PILGRIM WATCH'S 2.206 PETITION TO MODIFY, SUSPEND, OR TAKE ANY OTHER ACTION TO THE OPERATING LICENSE OF PILGRIM STATION UNTIL THE NRC CAN ASSURE EMERGENCY PREPAREDNESS PLANS ARE IN PLACE TO PROVIDE REASONABLE ASSURANCE PUBLIC HEALTH & SAFETY ARE PROTECTED IN THE EVENT OF A RADIOLOGICAL EMERGENCY

The primary basis for this petition is two recent documents prepared by KLD for Entergy: The *KLD Pilgrim Evacuation Estimate December 12, 2012 Final Report KLD-TR-510*² (Hereinafter, "ETE") and the attached *KLD MEMO to John Giarrusso (MEMA) from Chris Chaffee (KLD) Regarding the Cape Cod Telephone Survey Results*, July 25, 2013, attached (Hereinafter, "Cape Survey"); and the attached August 16, 2013 Letter from Senator Markey and Senator Warren regarding Pilgrim's ETE and Cape Telephone Survey to Leo Denault (Entergy) and forwarded to Chairman MacFarlane's Office.

Figure 2. Evacuation Due to an Incident at PNPS

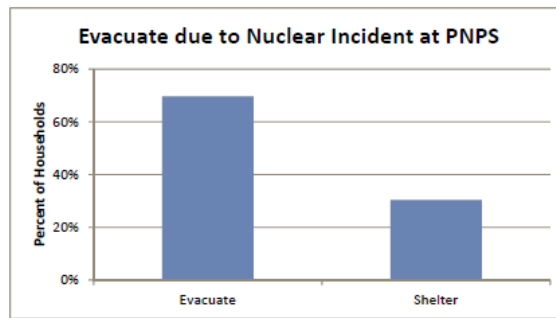
It is hardly surprising that many more respondents said they would evacuate when they were told that there had been a nuclear incident at Pilgrim than if neither Pilgrim, nor nuclear, nor radiological were even mentioned. The Cape Telephone Survey clearly demonstrates that the ETE Telephone Survey, that intentionally did not tell respondents upfront that the question refers to what they would do if there was an accident at the nuclear power plant, is not credible and cannot provide any basis for Pilgrim’s evacuation time estimates.

Figure 3. Voluntary Evacuation Due to an Incident at PNPS

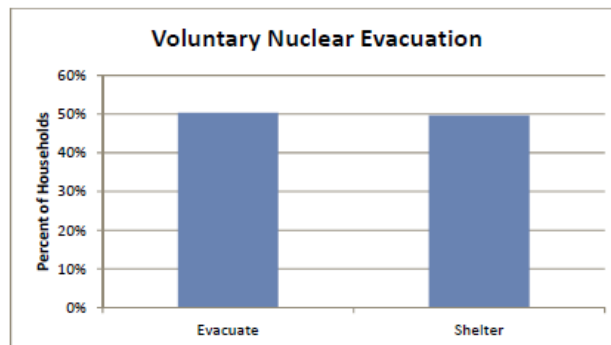
The Cape Survey, in stark contrast, told respondents the purpose of the survey and because it did the shadow evacuation estimates were very large. The Cape Survey specifically asked respondents, “If you were told that Cape Cod is not in the Emergency Planning Zone for the Pilgrim Nuclear Power Station, would you still evacuate? (Cape Survey Question 3B), “Approximately 50 percent of the Cape Cod residents indicated that they would evacuate due to a nuclear incident at PNPS, even knowing they were not in the Emergency Planning Zone (EPZ (Cape Survey, 4)

The results of the Cape Survey show, at a 95% confidence level, that the ETE's assumption that no more than 20% will evacuate is not just wrong; it is ludicrous. It cannot properly be used to determine Pilgrim’s evacuation time estimates.
